Bulletin No. 2002-16

## Resistor Contact with Steering Cable

Tour & Tour Edition 36 Volts models manufactured prior to August 1, 2002  
TE7107V, TE7109V, TE7109VP, TR109FB, TR109PFB.

00288

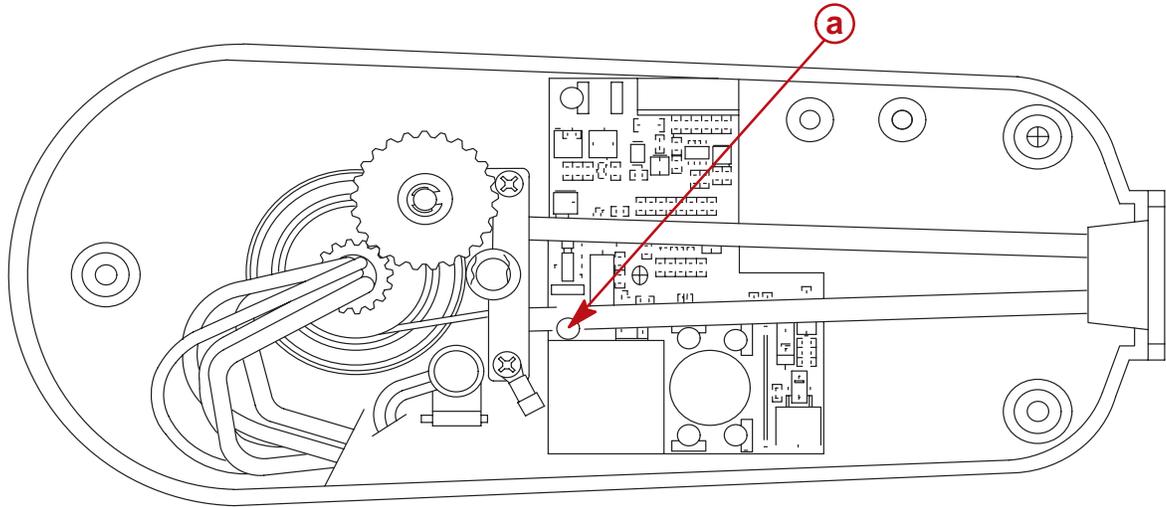
The resistor on the circuit board that is marked R34 can come in contact with the steering cable. If this happens, heat from the resistor may cause the insulation around the steering cable to melt, which can lead to electrolysis and/or corrosion.

When replacing or installing a control board in a Tour or Tour Edition, care must be taken to bend the resistor marked R34 at a 45 degree angle so it does not come in contact with the steering cable housing. Be careful not to bend the resistor too far, causing it to break or become detached from the circuit board. Inspect trolling motors prior to sale and make appropriate corrections as needed.

**a** - R34 resistor (Bend at a 45 degree angle)
